AMA9 – Replacing Threaded Connections on Rear Trailing Arm (Stop Delivery/Recall Campaign)

Model Line: **Cayenne (9YA)/Cayenne Coupé (9YB)**

Model Year: **2021**

Concerns: **Rear-axle trailing arms**

Installation position of trailing arm

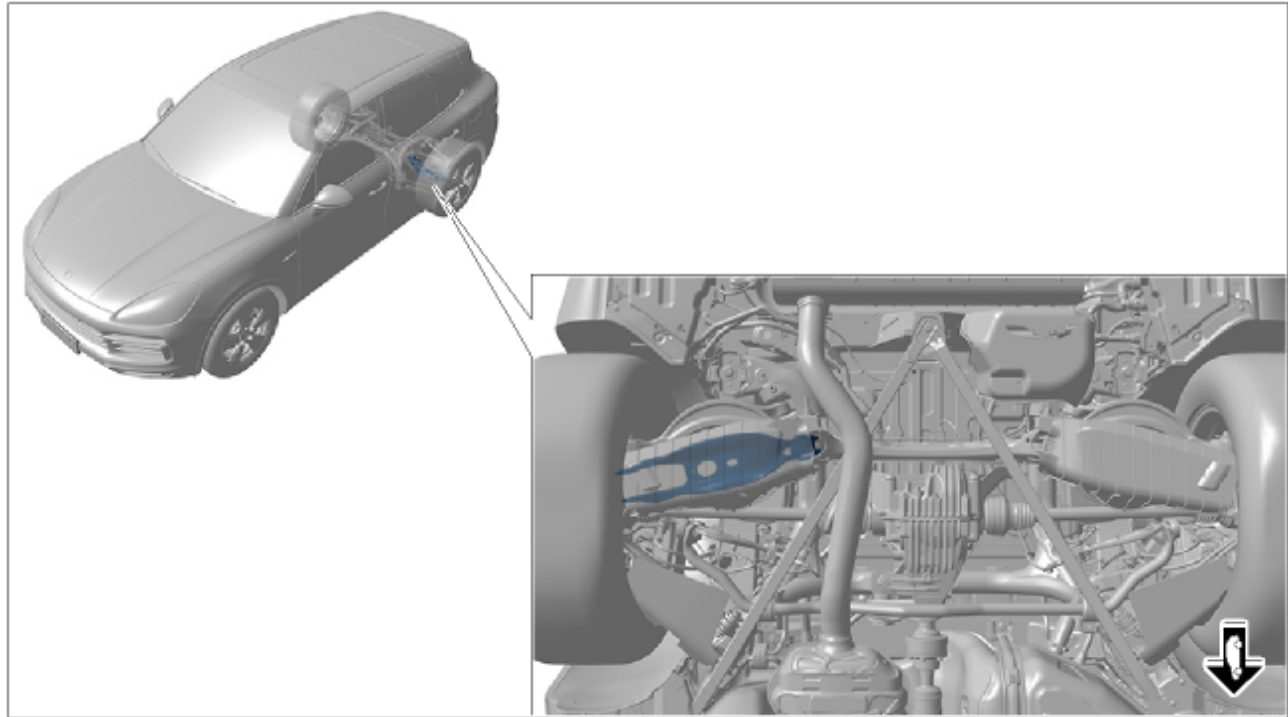
Information: **There is a possibility that clamping nuts that were not manufactured within the specified parameters were installed on the rear-axle trailing arms on the affected vehicles.**

This can result in stress corrosion cracking on the clamping nuts, which may cause the clamping nuts to break over the service life of the vehicle. A broken clamping nut can result in increased play between the trailing arm and wheel carrier and as a result, vehicle handling may suddenly be impaired.

Action required: **Replace clamping nuts on the rear-axle trailing arms.**

Replacing clamping nuts on the rear left and right trailing arms

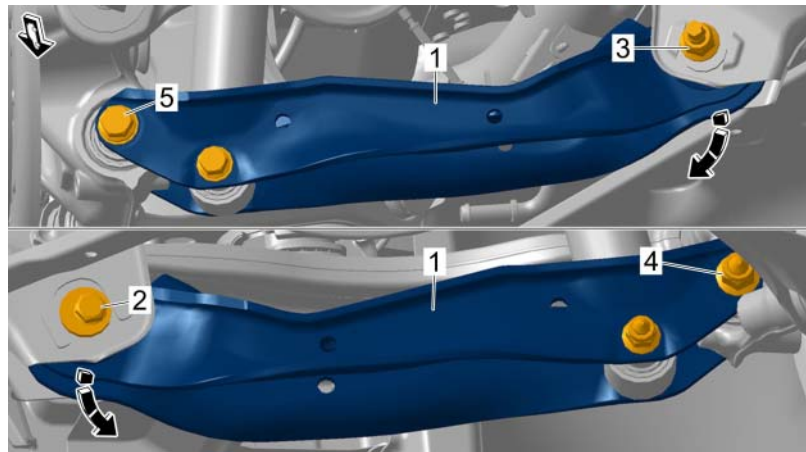
- Work Procedure: 1 Move the vehicle onto a lifting platform and raise it. ⇒ *Workshop Manual '4X00IN Lifting the vehicle'*
- 2 Remove rear wheel at the left and right. ⇒ *Workshop Manual '440519 Removing and installing wheel'*
- 3 Visually check the clamping nuts on the **rear left and right trailing arms** and replace clamping nuts:
- 3.1 Before removing the clamping nuts, perform a **visual inspection** to see whether there are **stress cracks similar to those shown** in the illustration ⇒ *Stress cracks on clamping nuts* -**Arrows**- or whether the clamping nut is broken, loose or missing.

Stress cracks on clamping nuts

- If you see **no sign of damage** at the clamping nut, **only the clamping nut must be replaced**. To do this, **continue with Step 3.2**.
- If the **clamping nut is damaged** or if the clamping nut has come loose or was lost, get in touch with your contact person at **Technical Support** to agree on how to proceed. In this case, a **PRMS ticket** for repair approval must be sent to PAG_Support_Campaign_TI_SY.

- 3.2 Using lifting equipment, raise the wheel suspension as far as necessary so that the screws of the trailing arm ⇒ *Trailing arms - vehicles without air suspension -1-* can be loosened.

- The **fastening screw** (expansion screw) on the wheel carrier **must be re-used**. It has been checked and approved for re-use one time only in this specific case.
- Position **eccentric screws exactly** at the previously applied **marking**. There will then be **no need to perform suspension alignment and make any adjustments to the vehicle**.

- 3.3 Before loosening the eccentric screws, mark the eccentric position. Mark the position of the eccentric screws ⇒ *Trailing arms - vehicles without air suspension -2+3-* on both sides using a pen.
- 3.4 Unscrew clamping nut securing trailing arm ⇒ *Trailing arms - vehicles without air suspension -3-* to rear axle housing and counter at fastening screw ⇒ *Trailing arms - vehicles without air suspension -2-* at the same time.
- 3.5 Screw on new clamping nut ⇒ *Trailing arms - vehicles without air suspension -3-*.

Tightening torque 140 Nm (104 ftlb.)

- 3.6 Loosen fastening screw ⇒ *Trailing arms - vehicles without air suspension -5-* securing trailing arm to wheel bearing housing by 1-2 turns and counter at the clamping nut ⇒ *Trailing arms - vehicles without air suspension -4-* at the same time.
Then, hold the fastening screw ⇒ *Trailing arms - vehicles without air suspension -5-* firmly and unscrew the clamping nut ⇒ *Trailing arms - vehicles without air suspension -4-*.

- 3.7 Screw on new clamping nut ⇒ *Trailing arms - vehicles without air suspension -4-* as far as it will go on the trailing arm.
- 3.8 Tighten fastening screw ⇒ *Trailing arms - vehicles without air suspension -5-* only in zero position to prevent warping in the bearings. Counter at the new clamping nut ⇒ *Trailing arms - vehicles without air suspension -4-* while doing this.
Initial tightening 130 Nm (96 ftlb.) Final tightening +180°
